Subject: Response to Comments on Toner Ranch Pit, M2021-011

This letter responds to your comments in the letter of adequacy dated 4 May 2021. I follow the numbering in that letter.

Exhibit E-2

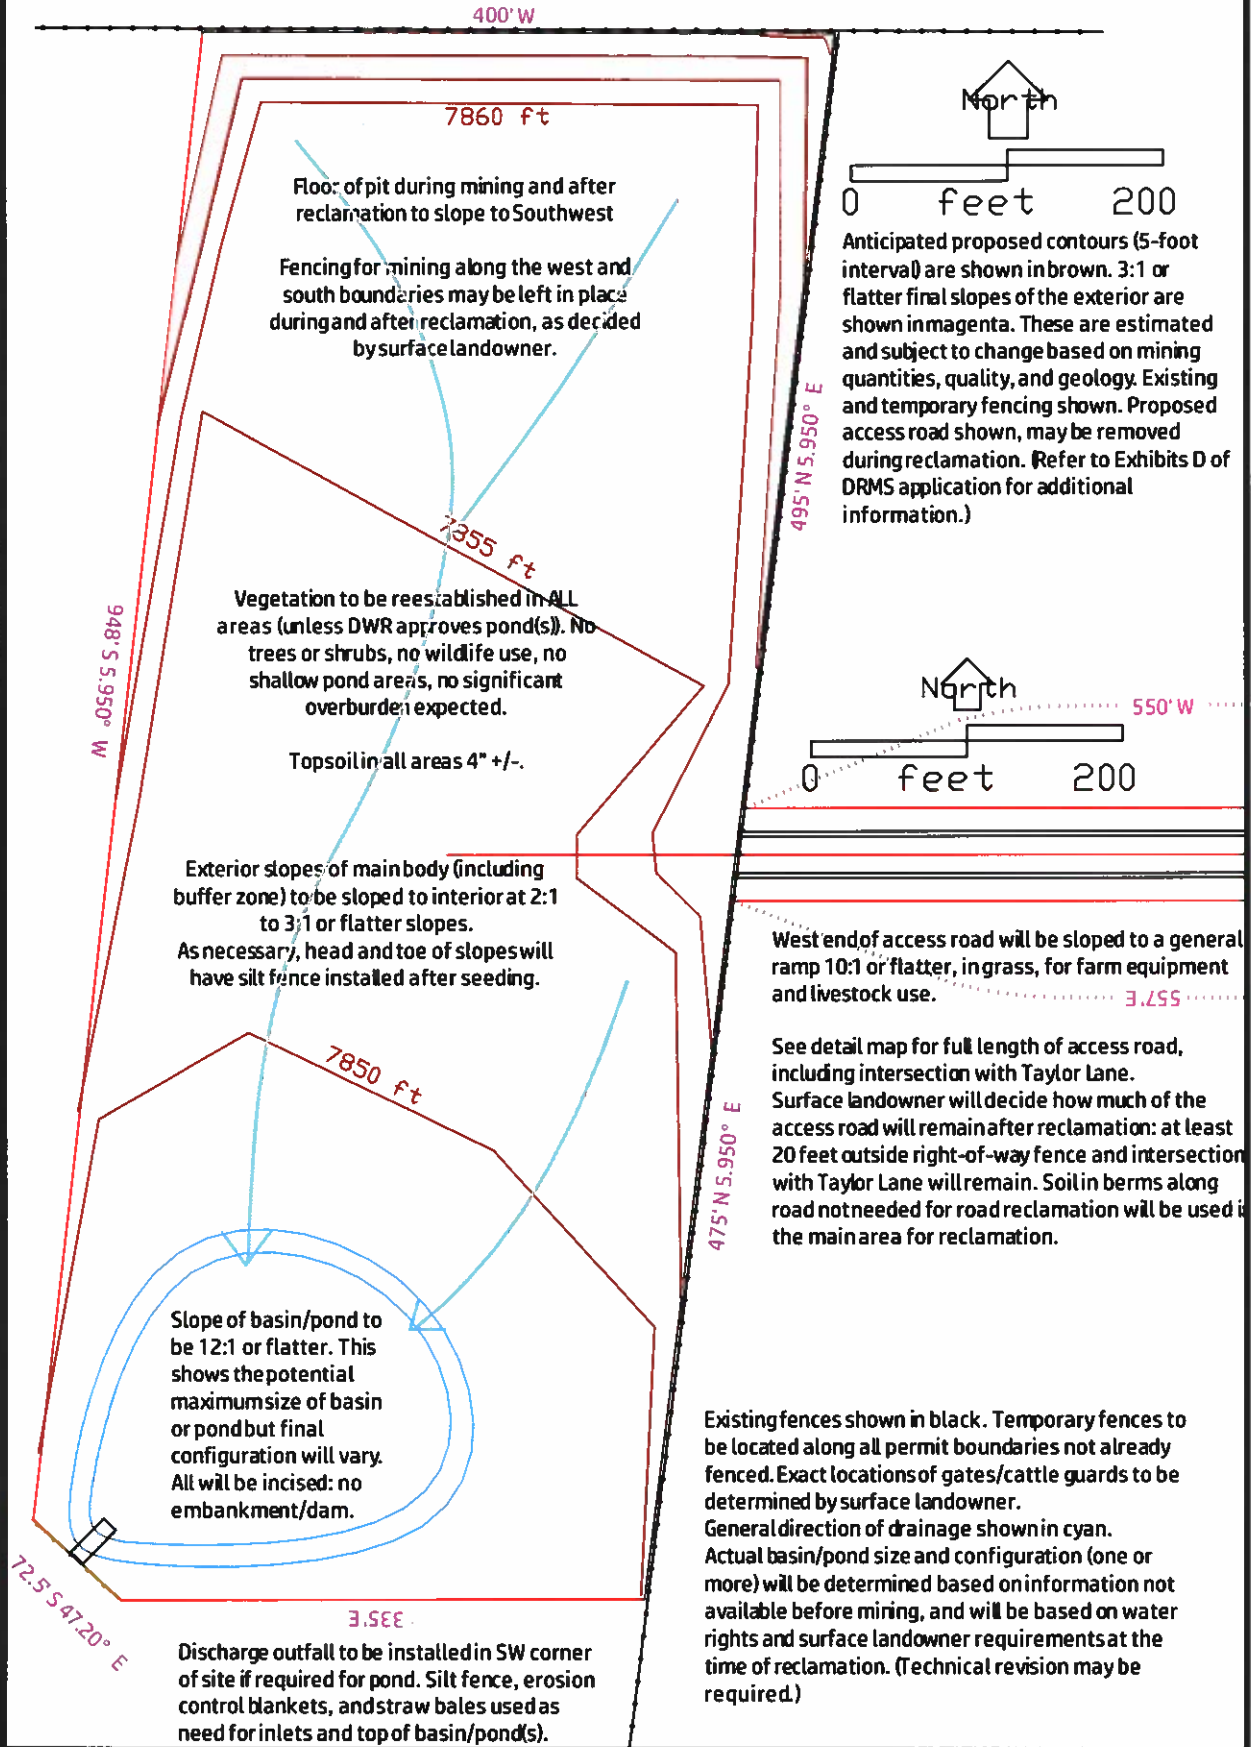
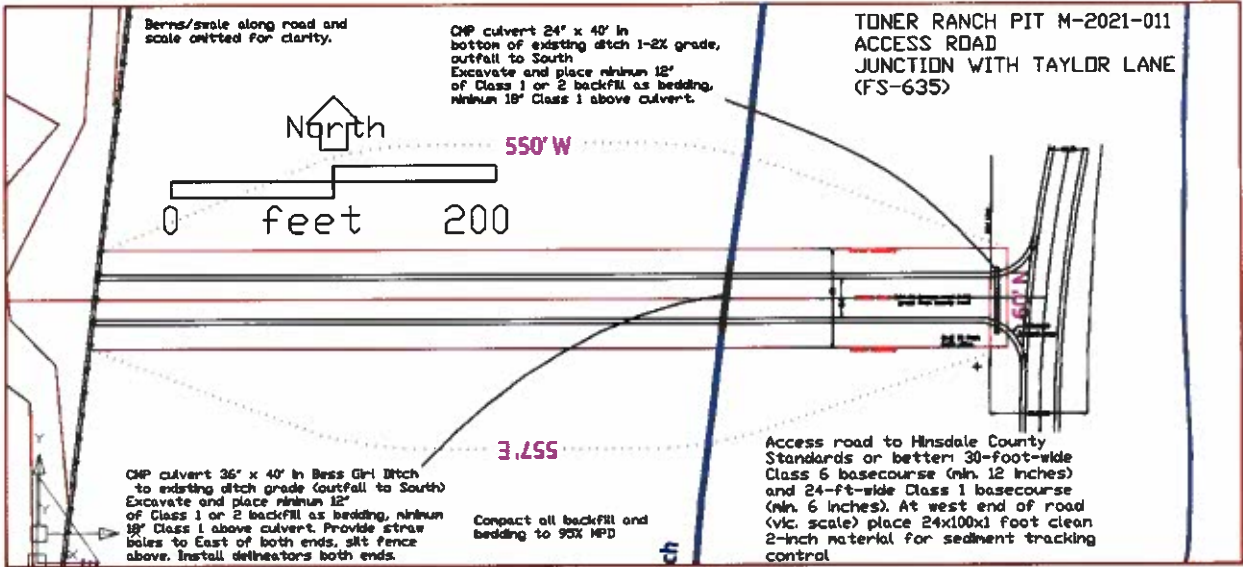
4. 6.3.5 Exhibit E Map. (Attachment 1 (3 pages) to this letter, replacing old Exhibit E)
 - a. While many of the items you requested cannot be added to these maps at this time, as explained above, we have revised Exhibit E to better show the items which CAN be shown at this time, including (as you suggested) various additional maps to better clarify the situation. We understand that a site of this size (less than 10 acres) seems to require far more detail than would be provided on a much larger site.

- a. See new Exhibit E revised maps (Attachment 1). Please note that the laterals are not considered (by the surface landowner) to be "significant manmade structures" as they all can and do change frequently.

- It is not possible to provide details and locations of most of the storm water control features because these will change significantly as mining and reclamation progresses. However, the major surface water control feature is the berm located within the buffer zone along the perimeter of the body of the pit, with its associated swale at the exterior foot of the berm. This is already shown in Exhibit E (maps), which now has a sketch showing key features.
